**ADDENDUM NO. 1  
TO CONTRACT DOCUMENTS FOR THE  
PERMANENTE CREEK FLOOD PROTECTION PROJECT-  
CHANNEL IMPROVEMENTS  
Project No. 26244001; Contract No. C0625**

**ADDENDUM NO. 1  
PERMANENTE CREEK FLOOD PROTECTION PROJECT  
CHANNEL IMPROVEMENTS**

**REPLACE** in their entirety the following drawings (**ATTACHMENT 5**):

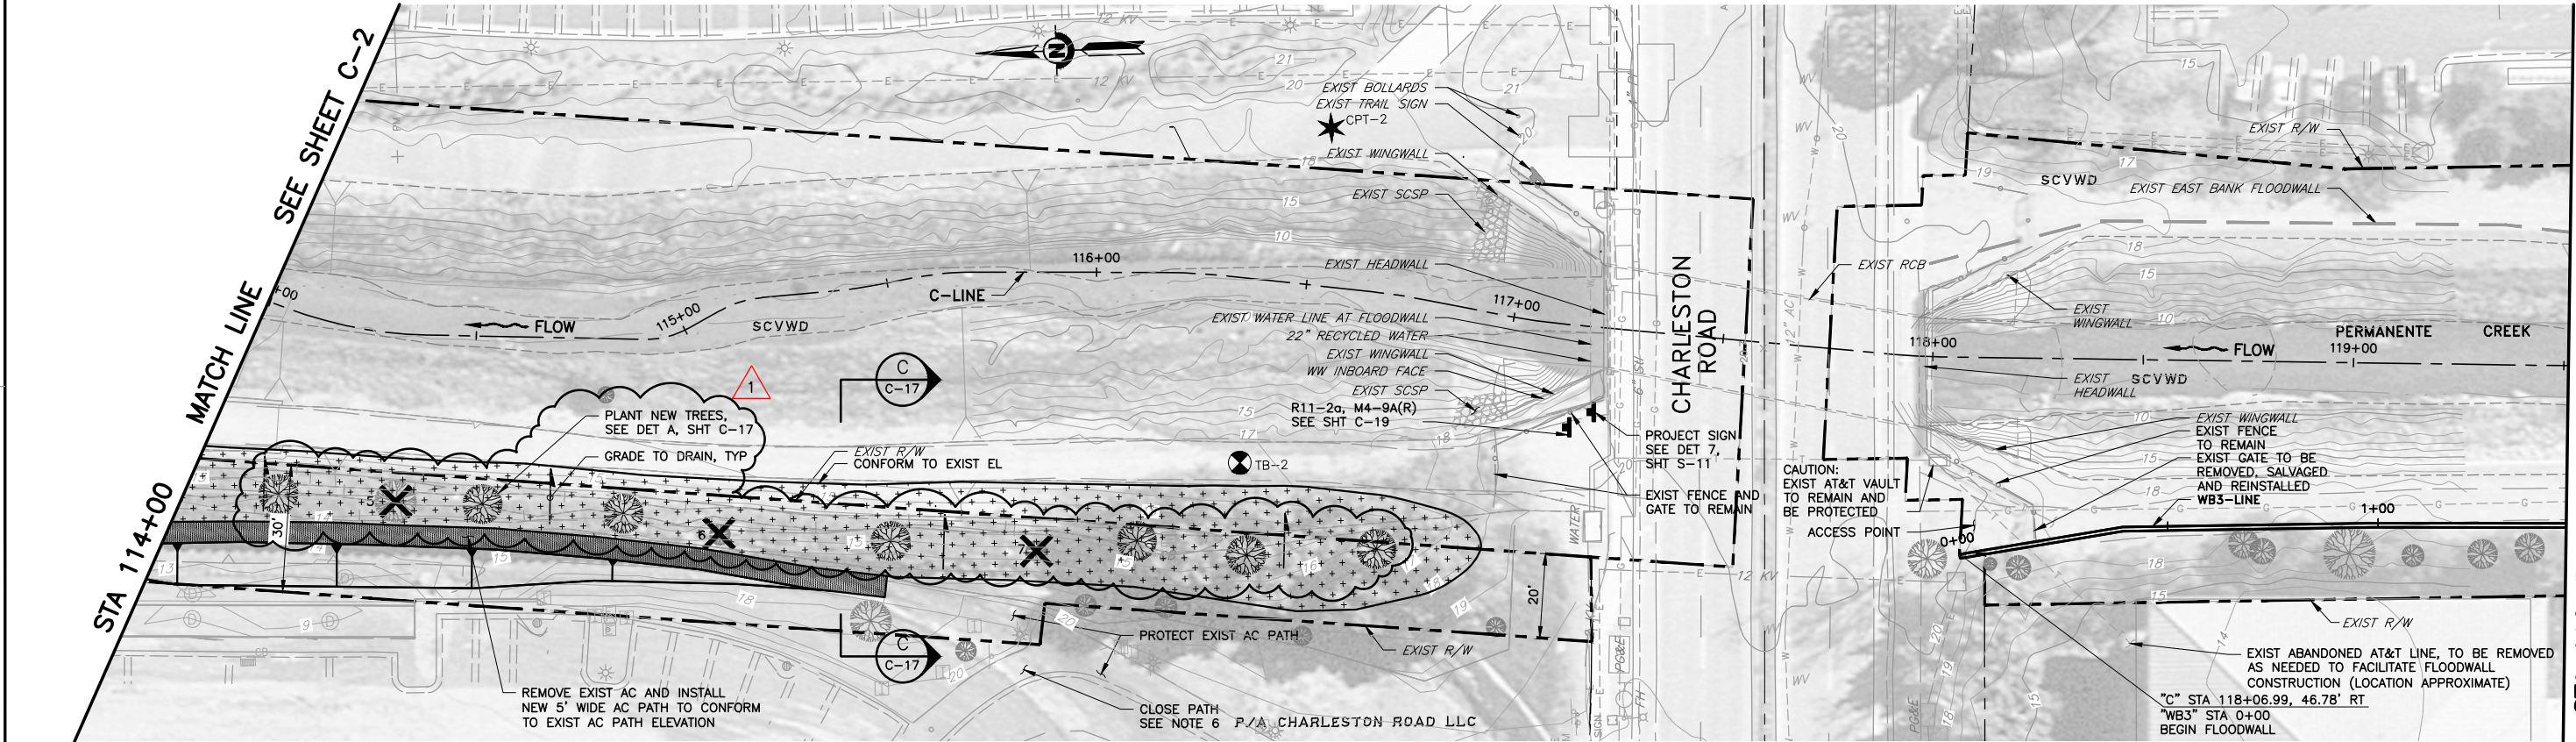
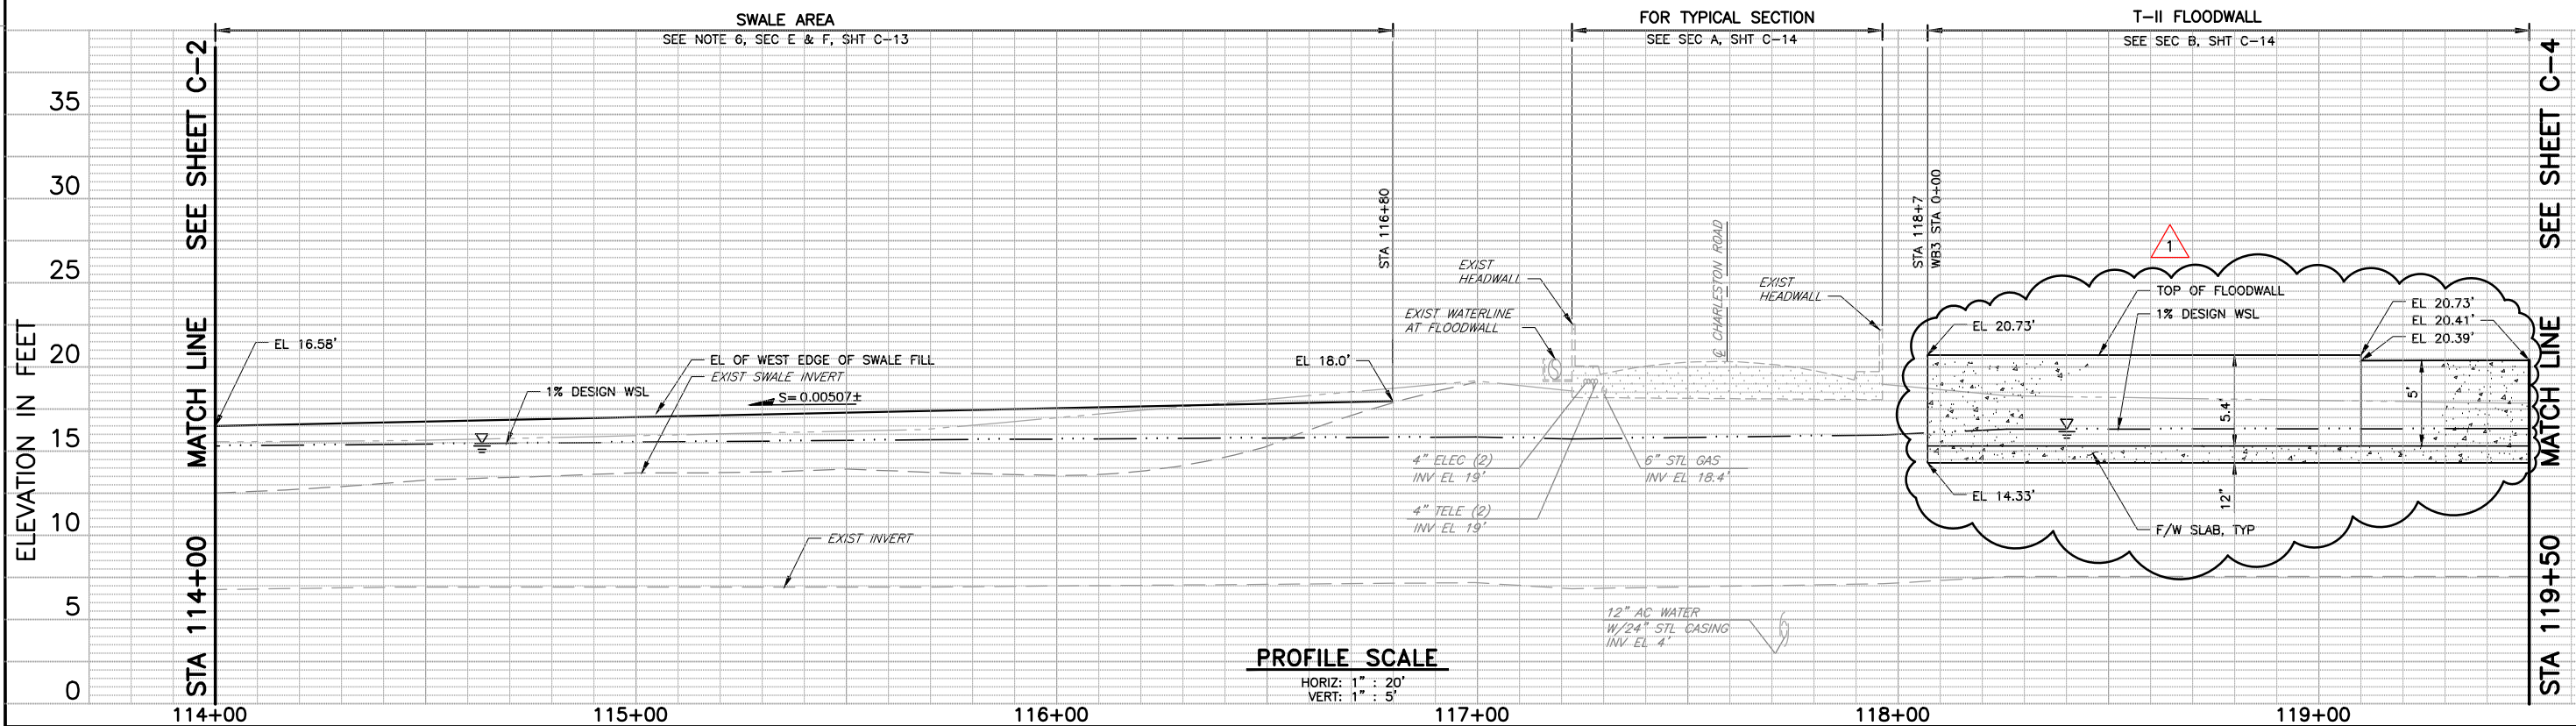
Response 29	No, the Contractor is not to assume that they will have the buffer.
Question 30	On sheet C-3, in the profile view, Station 118+7 you have Top of Wall at EL 20.33' and bottom of footing at EL 15.33'. So that's 5' from top of wall to bottom of footing, but the dimension shown in both the profile view and the detail on Sheet S-2 show 5'-10" from Top of Wall to Bottom of Footing. Can you confirm which is correct?

Response 30	Please refer to this Addendum No. 2, Sheets C-3 and S-2.
Question 31	<p>Sheet C-8, Note 4 says "Trees not listed for removal that hinder construction operations may be removed with the Engineer's approval." Page 11 of the Fish and Wildlife Permit in the Appendix C says "For the concrete channel length from station 251+14 to station 262+30 (near Hale Creek confluence), the west bank of the channel will be left in place and supported with steel I-beams and braces to shore the west bank, <b>while the east bank will be sloped back.</b>"</p> <p>Following the guidelines of the permit and sloping the East Bank back at this location, the majority of the trees along McKlevey Park and the school shown not to be removed will hinder construction operations (i.e. they will be in the sloped excavation zone). Will the Engineer grant permission to remove trees</p>

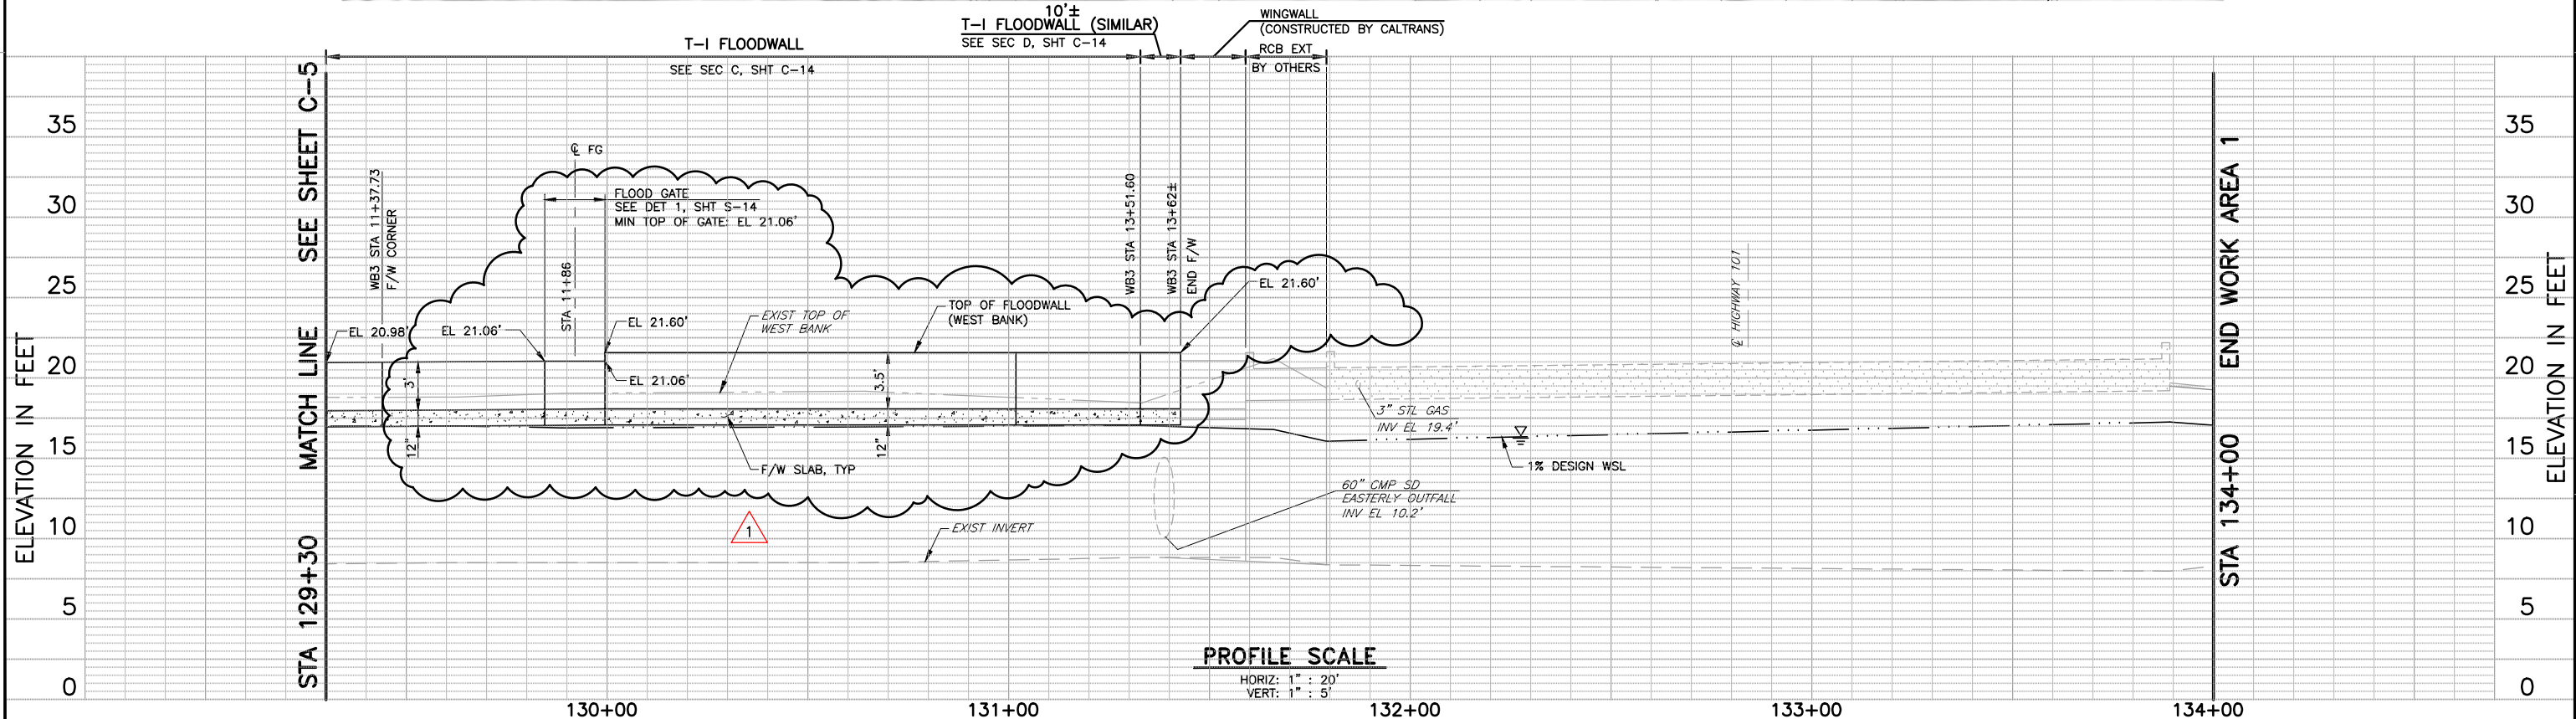
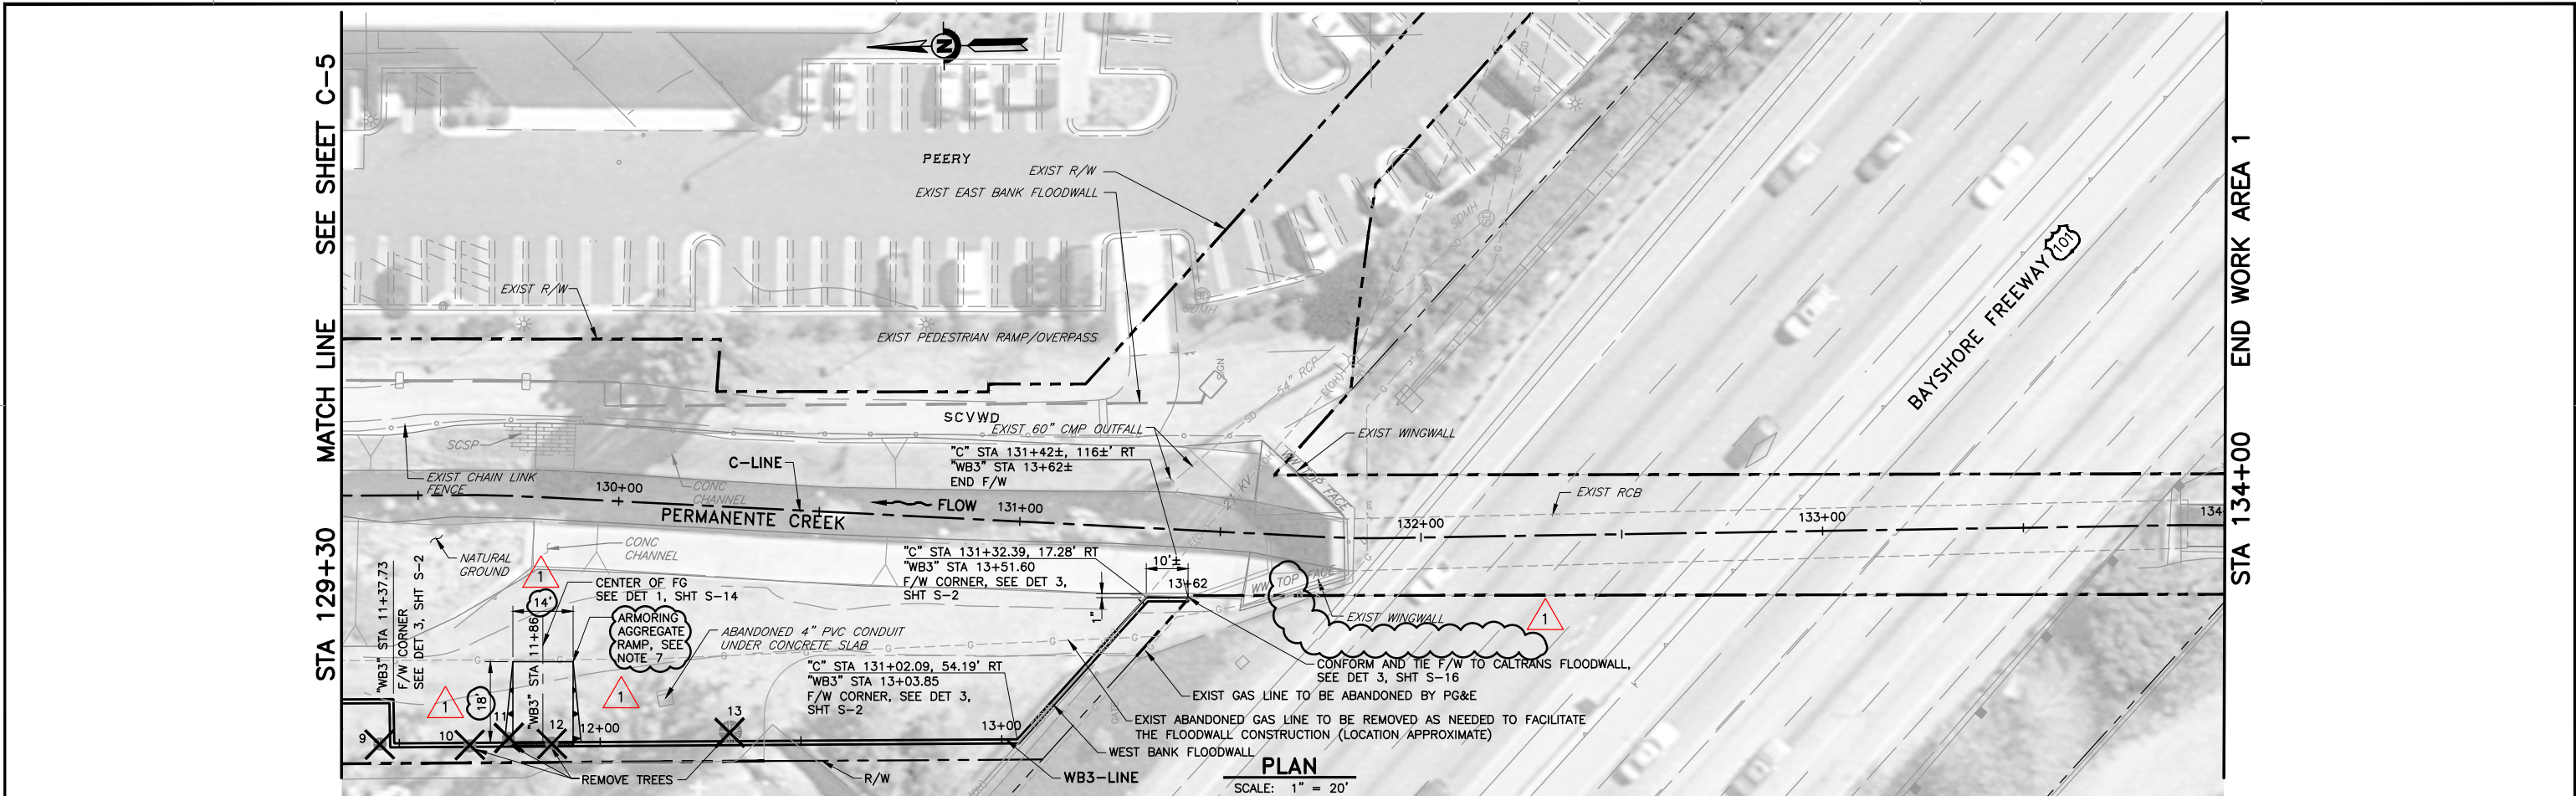
Response 7	Please adhere to the Schedule of Work as stated in Specifications Section 11.
Question 8	On Sheet C-6 on the Profile Scale at C/L Station 11+86 indicates the Flood Gate to be approx. 3' 10" in height with no indication of a footing. Also on C-6 on the Plan Scale at C/L 11+86 it shows what it appears to be a ramp on the armor aggregate side but has no details. On Sheet S-14 it indicates the Flood Gate to be 3' 4" in height with indication a footing. Please clarify with further details.

Response 8	Please refer to Article 24.11, Armoring Aggregate, of the Project Specification and Addendum No. 2, Drawing Sheets C-6 and S-14, the floodgate wall height shall be a minimum of 3' based on C-6. Drawing Sheet S-14 is a proposal drawing and the floodgate shall be installed in accordance with the manufacturer's recommendations and related sections of the contract documents.
